Product hierarchy no. *				Part no.	SBU	Type / Description	Customer part no.
SBU	PG	PGU	Type				
03	009	010	0000003008	1301.9303	Switches	LPH	
03	009	010	0000003008	1301.9305	Switches	LPH	
03	009	010	0000003008	1301.9307	Switches	LPH

Actuator dimensions have changed, see table below

LPH					0118.2163	
creation date	created by	release date	released by	notification no.	revision	page
2013-03-12	bisanger	2013-03-19	bisanger	24506	-	1 of 1

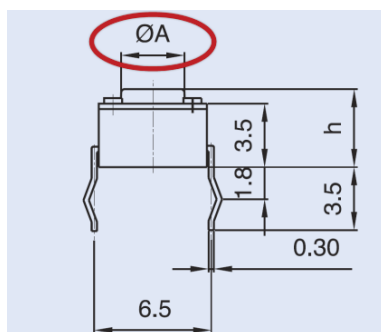
Part no.	Dimension A old [mm]	Dimension A new [mm]
1301.9303	Ø 3.2	Ø 3.3
1301.9305	Ø 3.1	Ø 3.3
1301.9307	Ø 3.0	Ø 3.4

Tolerance +/- 0.1
